To: Brad Ryan, Borough Manager, Municipality of Skagway  
From: Ross Hunnicutt, Construction Project Manager, KPFF Consulting Engineers  
Cc: Cody Jennings, Emily Deach, Ed DeBroeck, Rob Price

RE: Ore Peninsula Redevelopment Project, Pacific Pile & Marine  
**Change Order No. 006**

Date: April 24<sup>th</sup> 2024

RFI 102 - Observed delamination between beams and existing structure

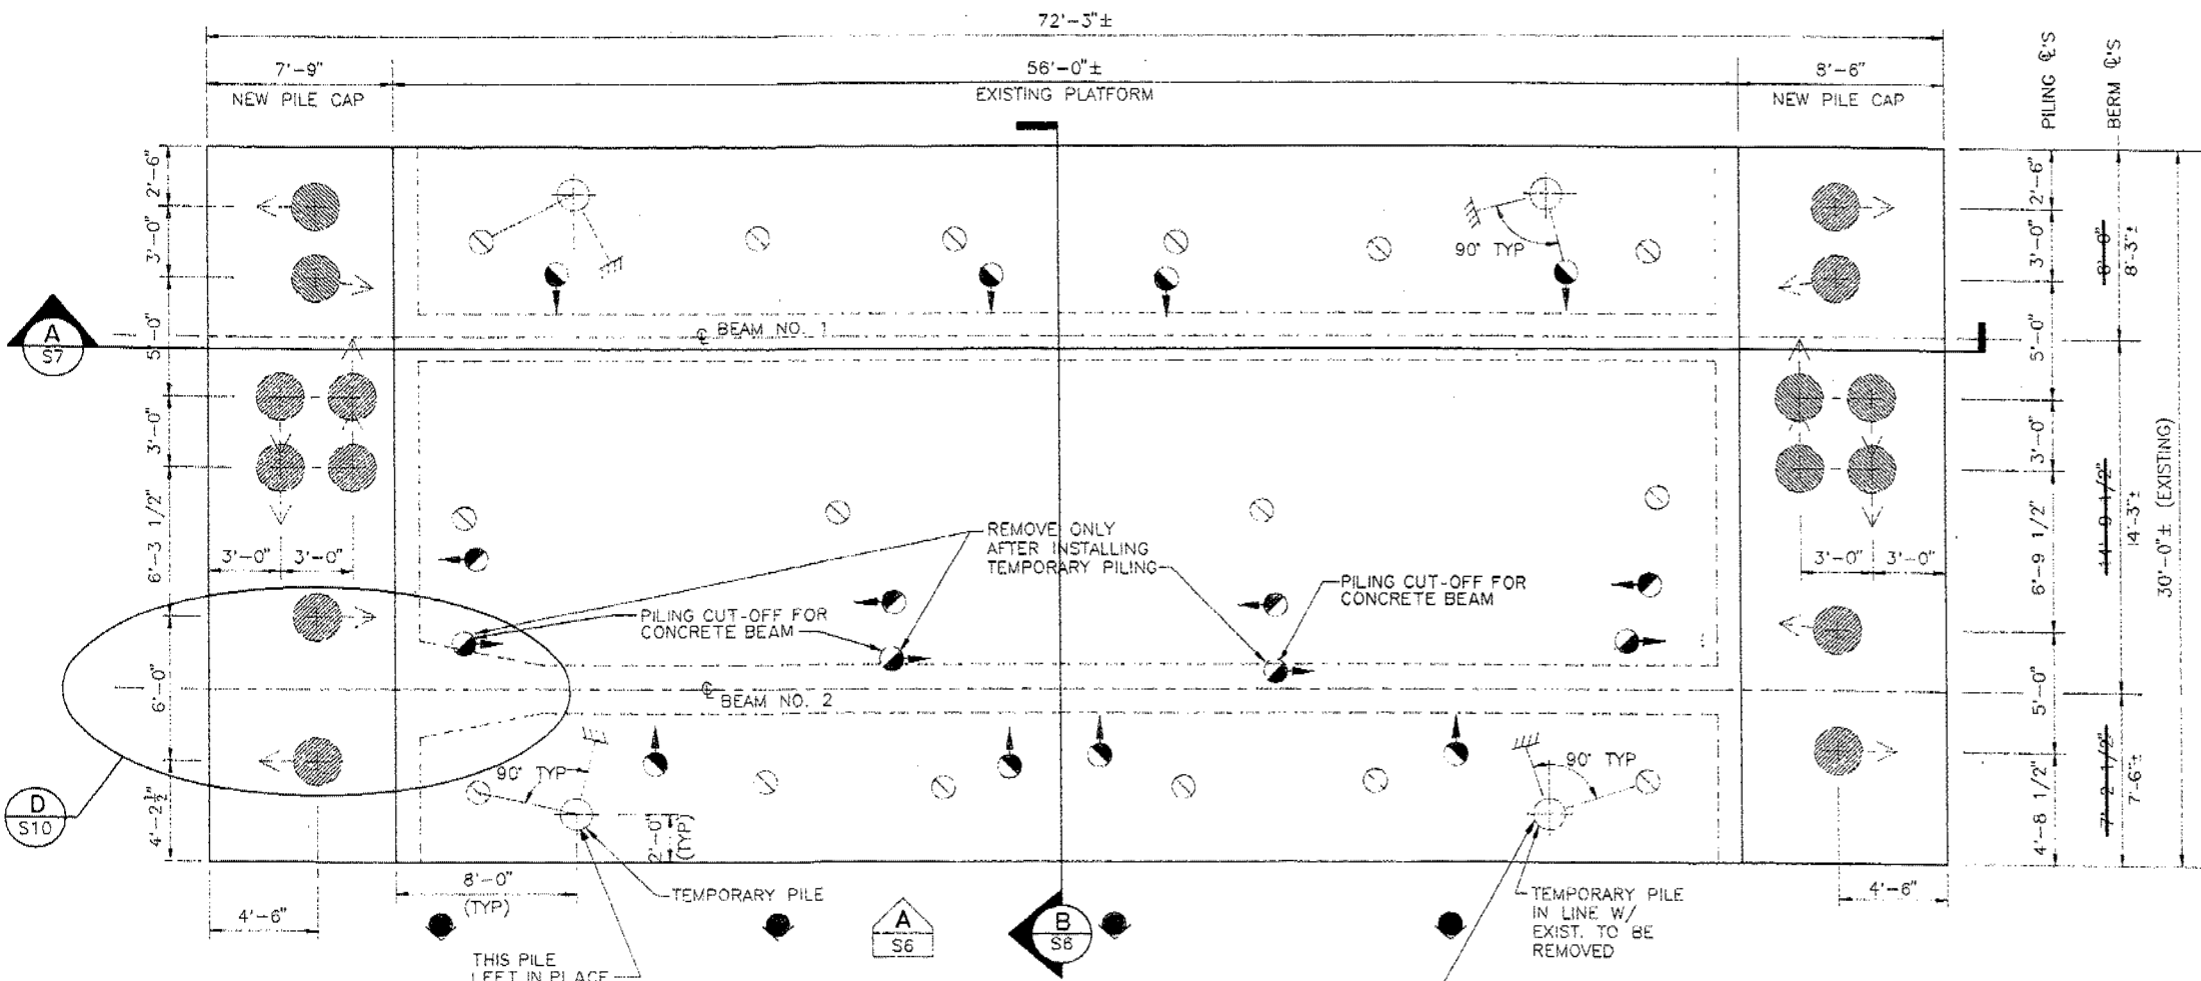
Please confirm that the proposed measures are acceptable to KPFF/MOS or provide additional direction.

As discussed in meeting on 11/22 PPM's engineer shall submit a stamped drawing and calculation package for the added supports to hold the beams. PPM's engineer would also need to submit calculations showing how they intended the beam to be self supporting and what is different from that plan in the existing conditions.

As discussed 3/2024 PPM to demonstrate/document locations of #7 bars holding soffit beam to onsite inspector during demolition

SOT03-1991-AB-S6, Loader Platform - Plan & Sections

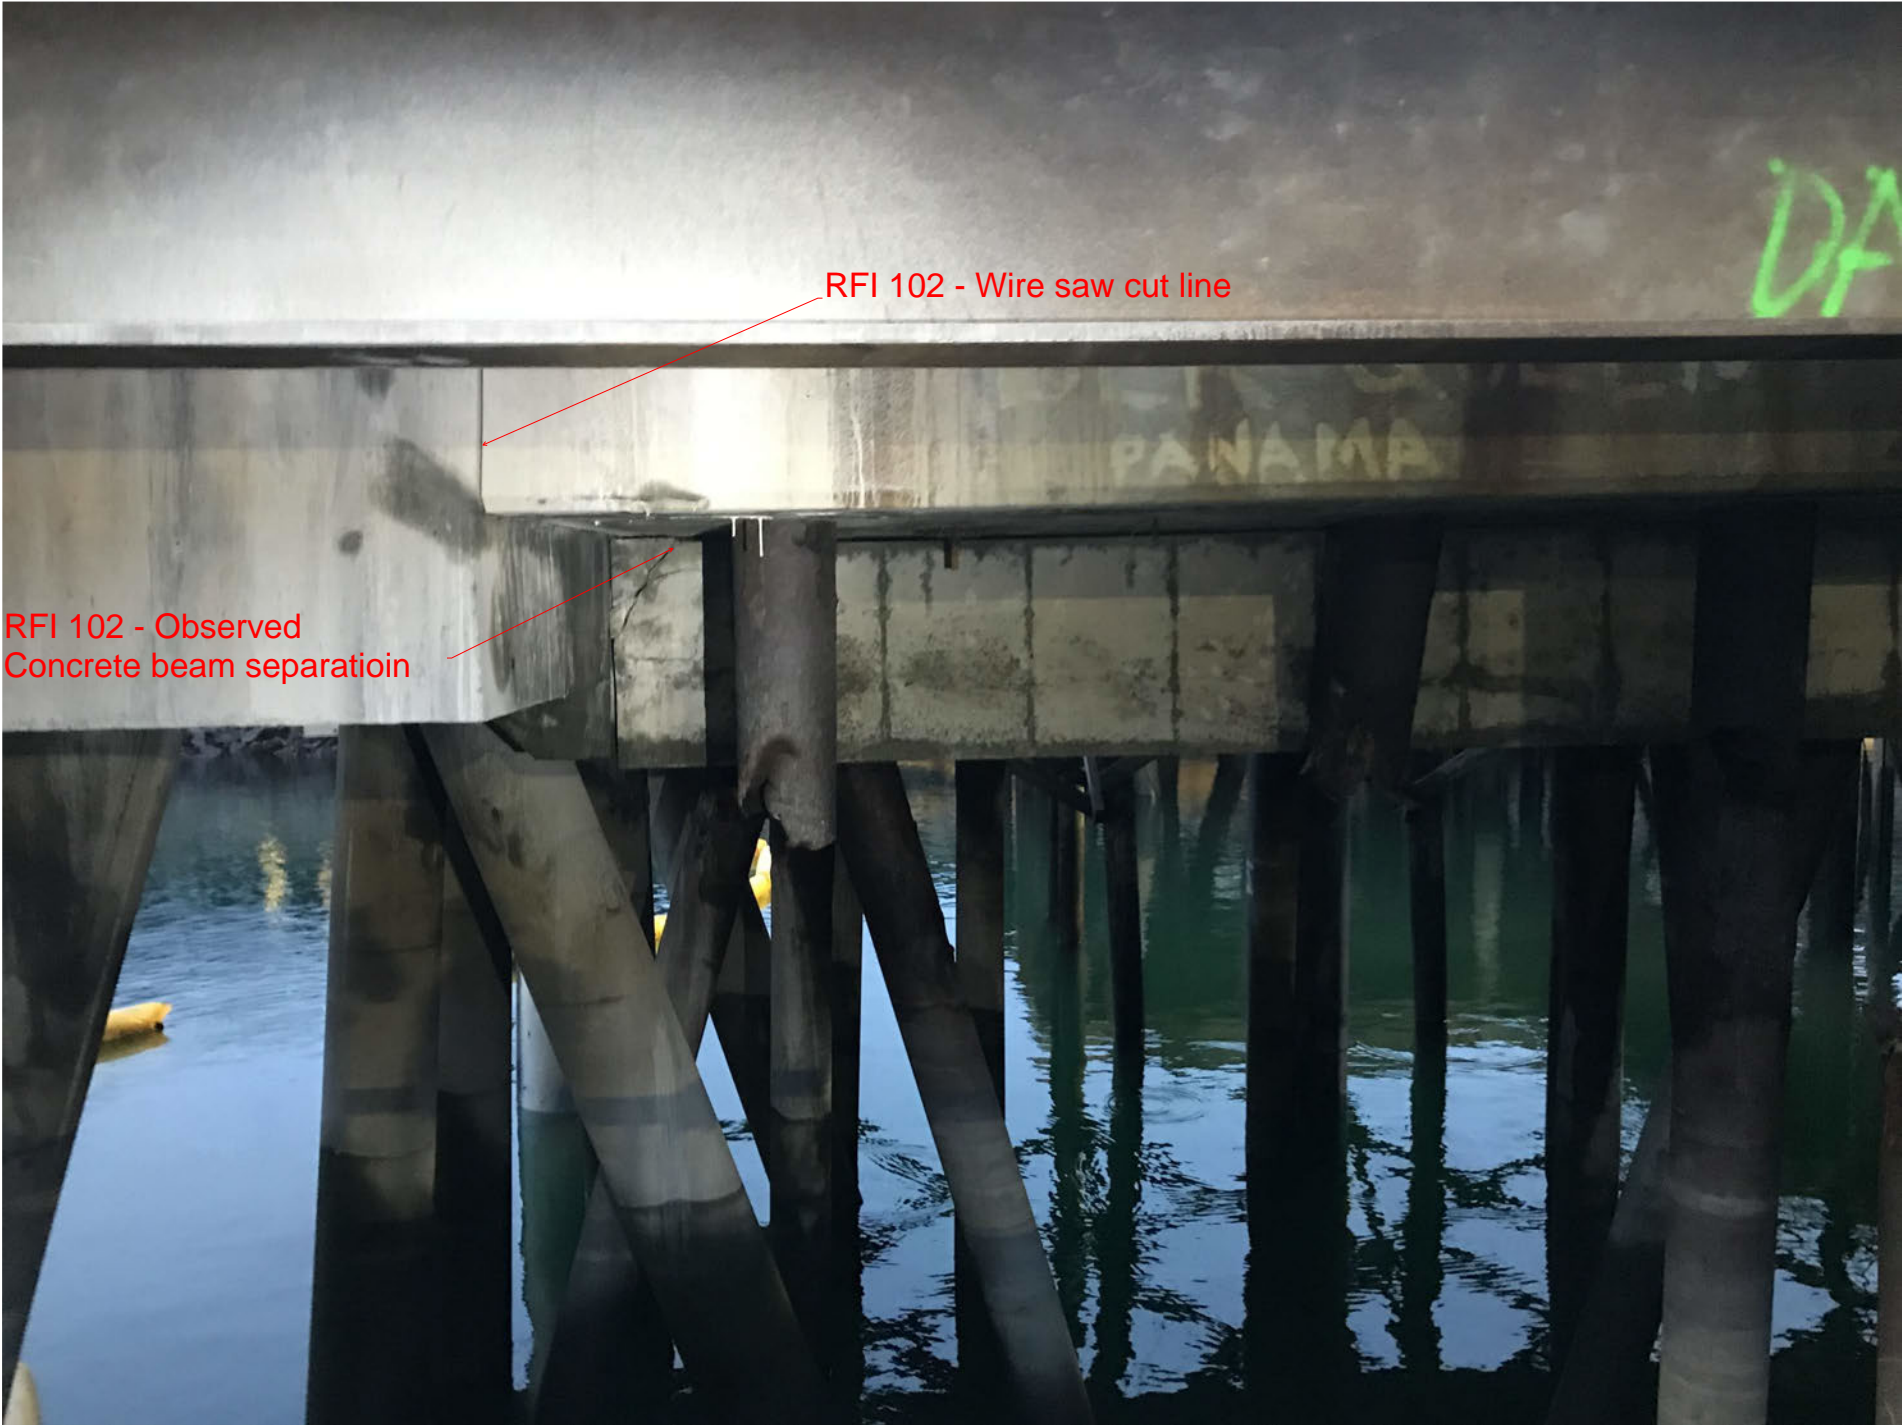
Appendix D Historical Drawings Loader Platform Details S6 and S7 show #7 epoxy coated dowels spaced at 8' on center to support Beam No. 1 and 2 under the ore loader platform.

PPM's third-party engineer, BMA Construction Engineers, provided calculations exhibiting the beams should have been self-supporting during the demolition of the platform provided the #7 dowels were installed per the Historical Drawings. Calculations are included in the RFI 102 VPO file.
